Service Technical Information

MODEL NO. AM-F70 / F65
SUBJECT Changes of component values in motor-drive circuit

REF.No. :G - 99 - 079 - E1

REVISION : Added confirming the thread operation of pick up in Countermeasure 4

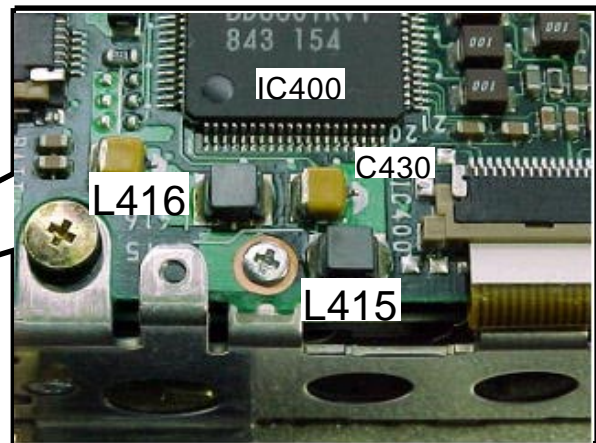
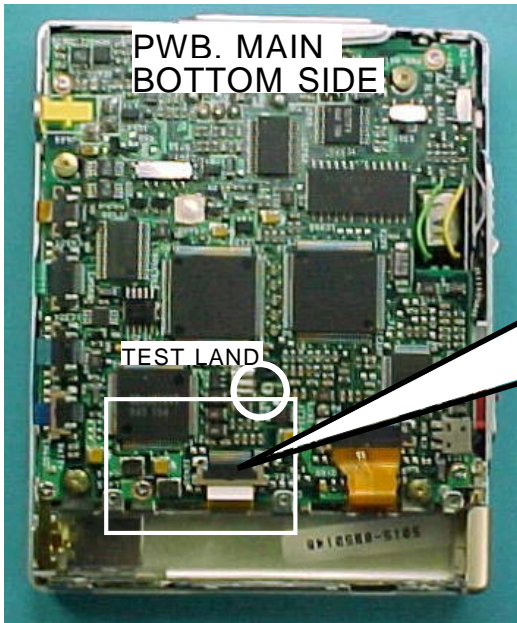
A fault may occur in IC400 or C430 of the models concerned.
 For avoiding the fault, component values of L415 and L416 shall be changed.
 L415 100 μ H \rightarrow 330 μ H , L416 47 μ H \rightarrow 100 μ H

- 1) Remove L416 (47 μ H).
- 2) Remove the coil of L415 (100 μ H), and mount the coil onto the land of L416.
- 3) Mount a 330 μ H coil onto the land of L415.
- 4) Start the TEST MODE (P-ON with the SYNCHRO SW set to OFF), and confirm the SLED operation of the pick up by pressing F-SKIP and B-SKIP.
 - The countermeasure is complete if the SLED operation of the pick up is smooth.
 - If the SLED operation of the pick up is not smooth, change L416 back to 47 μ H.
 Complete the countermeasure after checking again that there is no abnormality in the SLED operation of the pick up.

The 100 μ H coil used on L415 will be mounted on land of L416.
 Order a 330 μ H coil only.
